Nº 133 SERVICE BULLETIN

SUBJ: Monopoly® & Austin Powers CPU/Sound Board Modification
Low Volume Setting Hum

View the following page for the locations of R106 & R110 on the CPU/Sound Board.

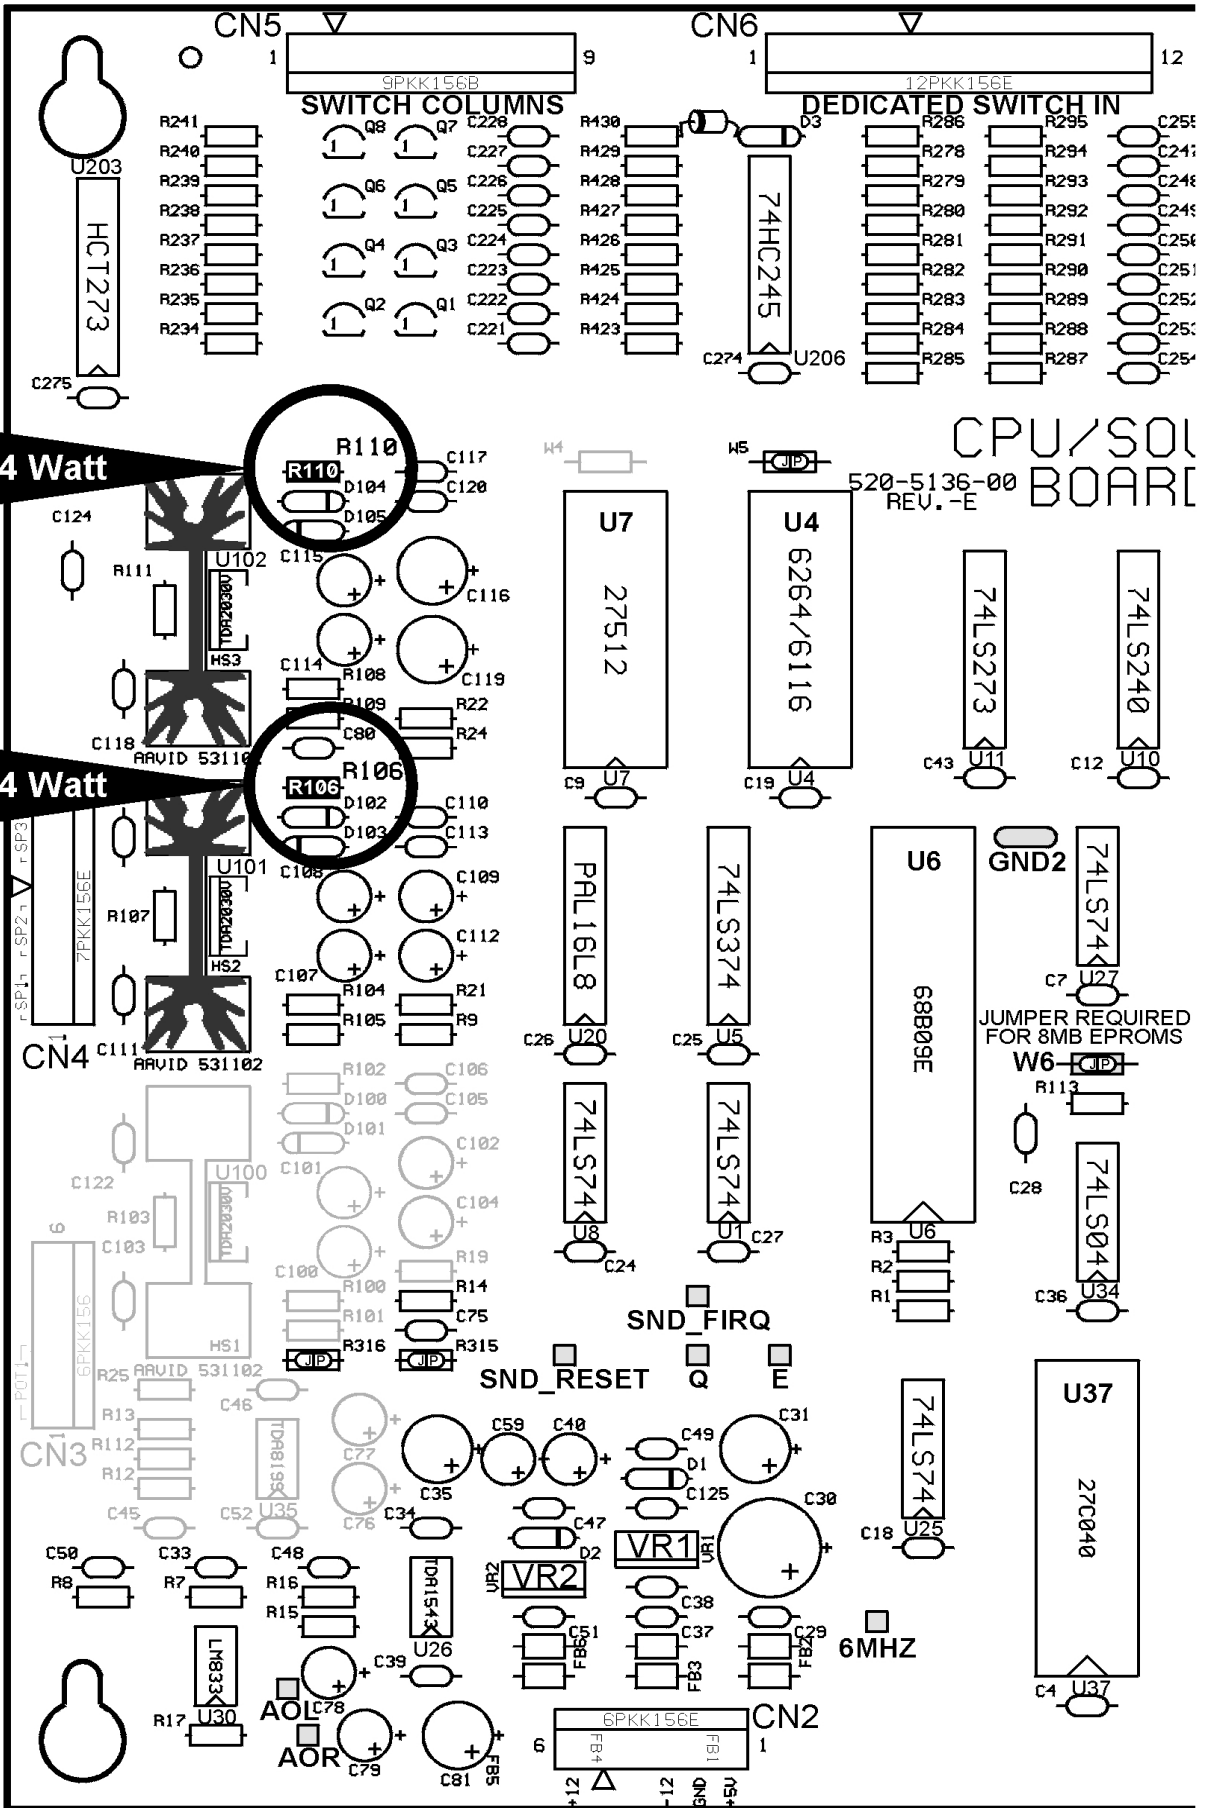
Due to the large number of games being sold in the "Home Market," it was brought to our attention that **at very low** volume settings, there is an undesirable hum in the audio. To eliminate the hum (at very low volume), we are suggesting two (2) Resistor changes which will reduce the gain of the amplifier, however, will ensure the proper balance between the upper and lower channels are intact.

Change
R110 to:

Change
R106 to:

Have a qualified technician change **R110** to a 33K Ω 1/4 Watt Resistor and change **R106** to a 10K Ω 1/4 Watt Resistor.

Resistor
33K Ω 1/4 Watt

Color Code:
ORG-ORG-ORG-GOLD

Resistor
10K Ω 1/4 Watt

Color Code:
BRN-BLK-ORG-GOLD
